**COUNTY OF VENTURA
PUBLIC WORKS AGENCY**

From: Gregg Strakaluse **Addendum No.1**
Director of Public Works

Subject: **Project Name: E.P. Foster Library Modernization**
Specification No. CP24-01
Bids to be Opened: Thursday, January 8, 2026 is changed to
Wednesday, January 14, 2026

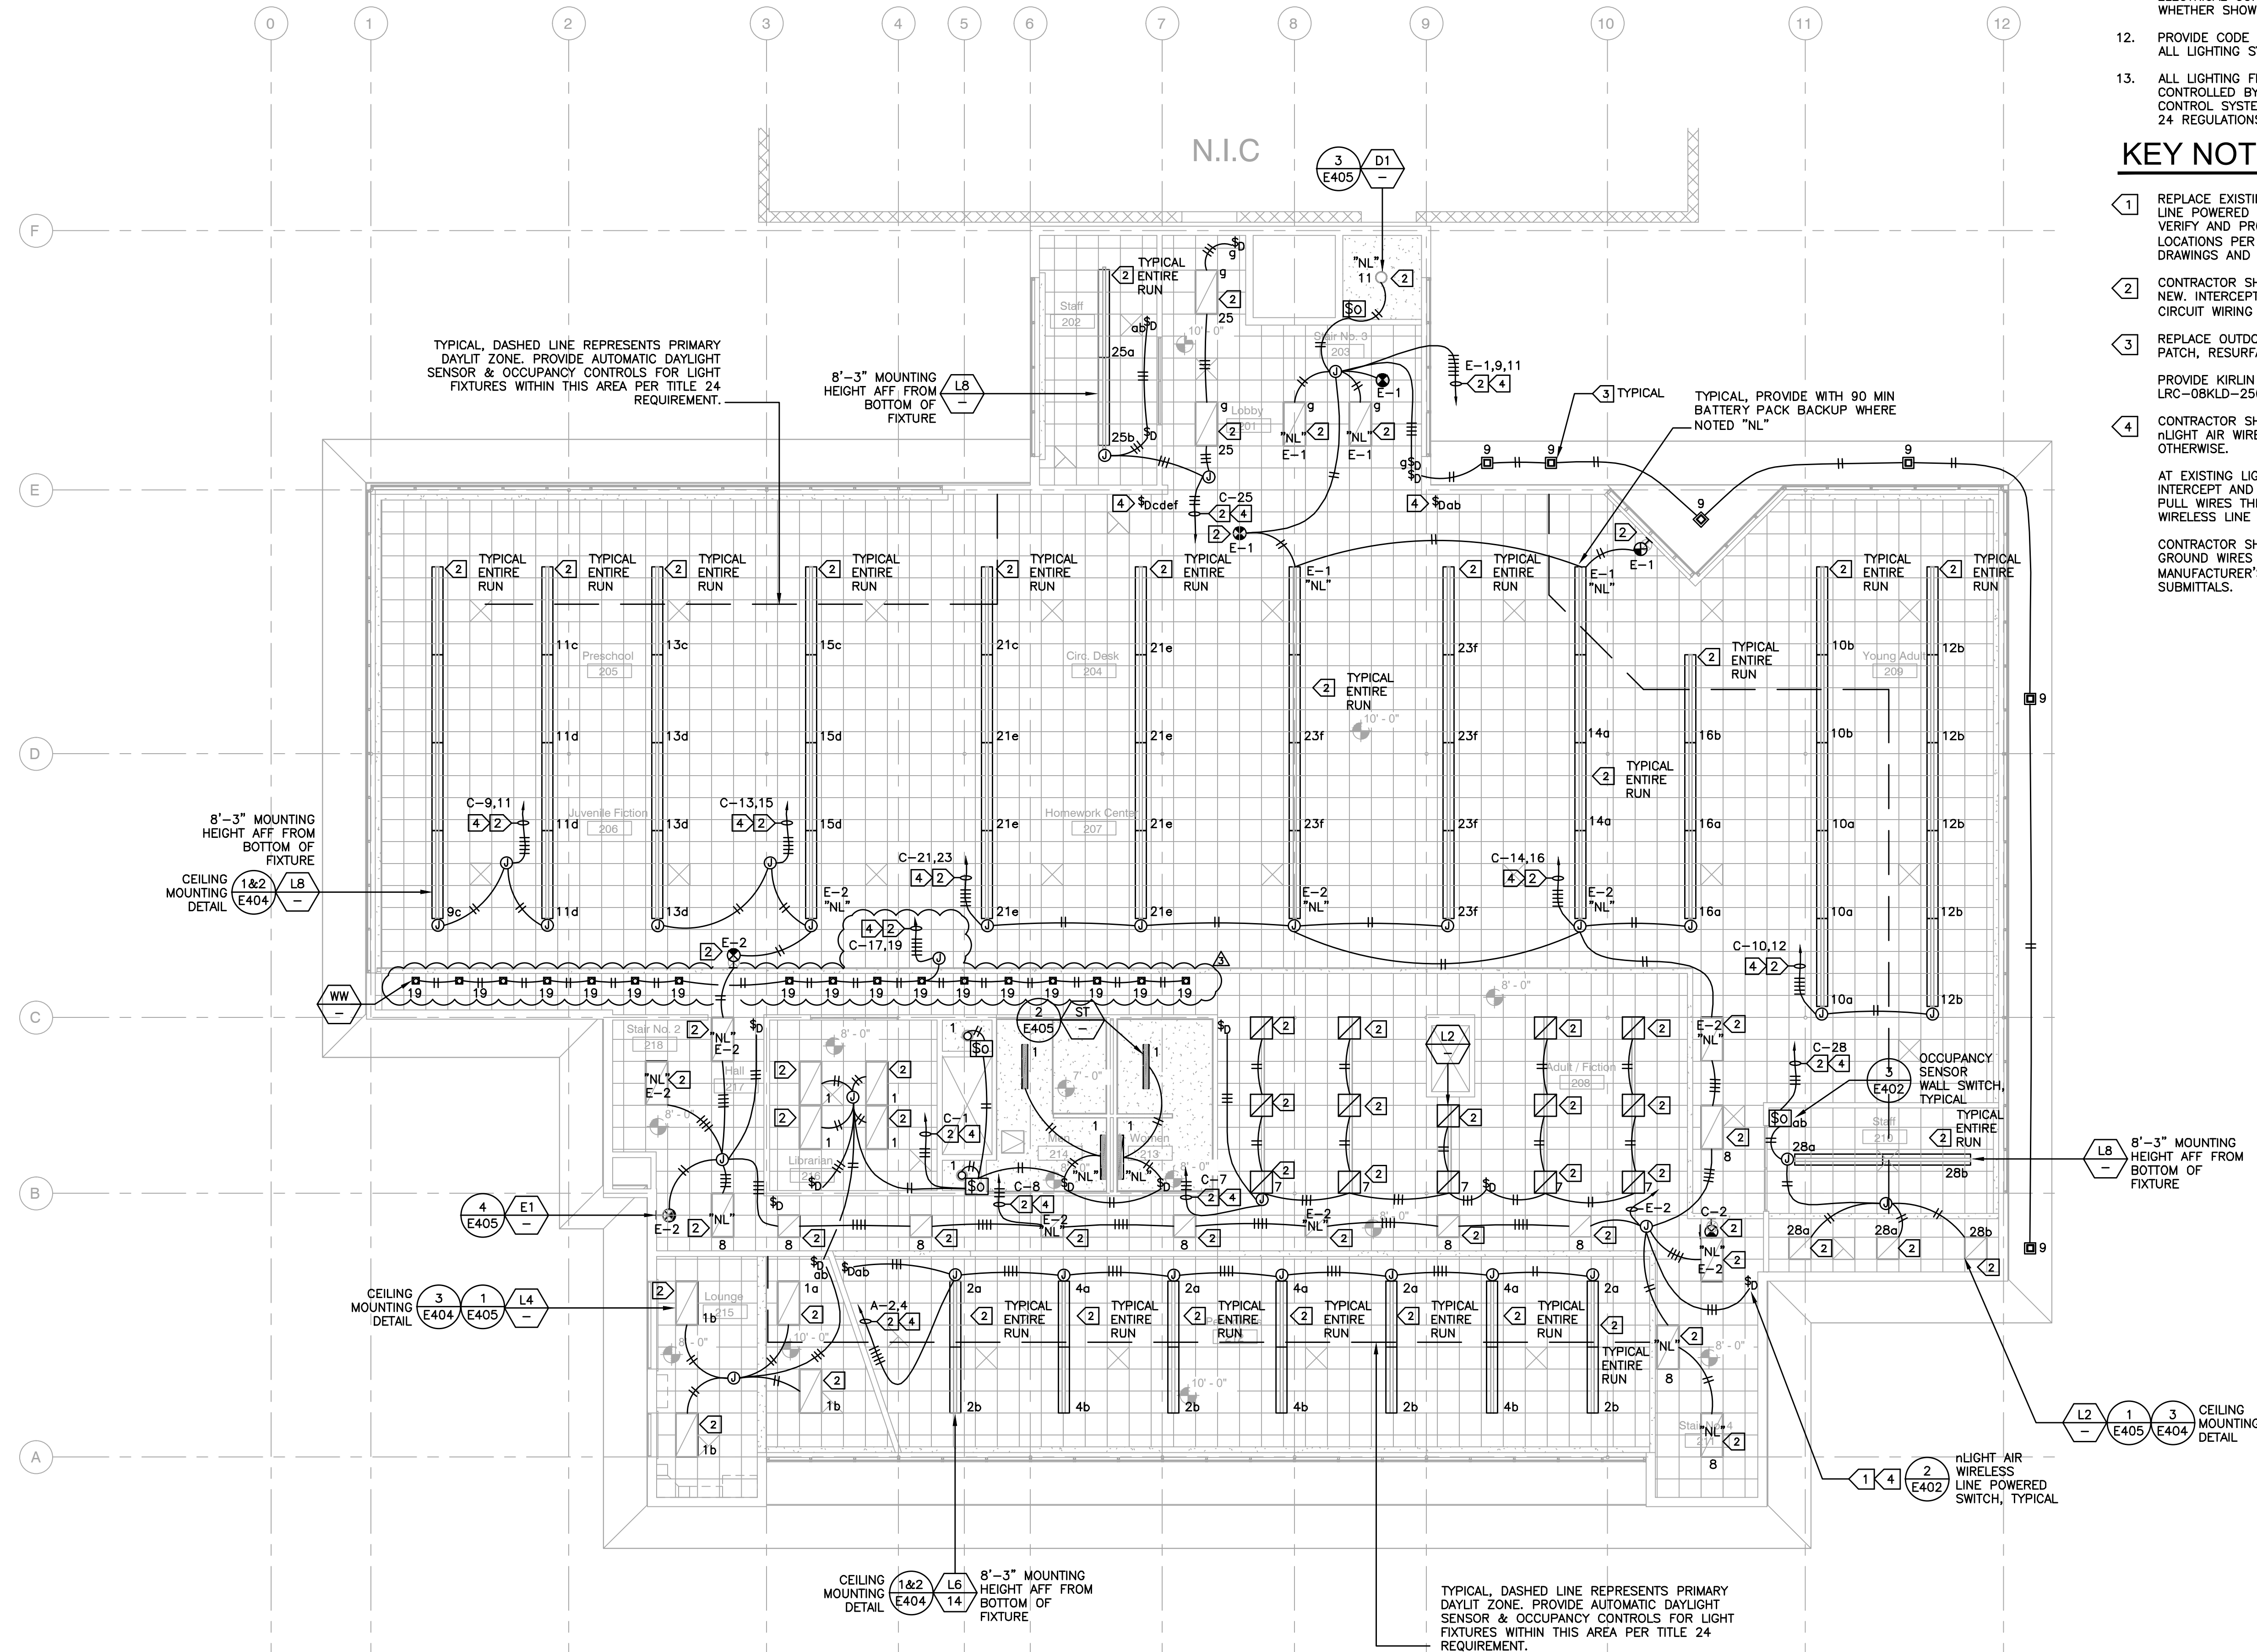
9. Replace Sheet E-402 – First Floor Lighting Plan with the attached Addendum No. 1 plan Sheet E-402 – First Floor Lighting Plan.
Explanation: See revision clouds. Added Wall Wash Light fixtures to replace existing. Added Light Fixture Type “WW”
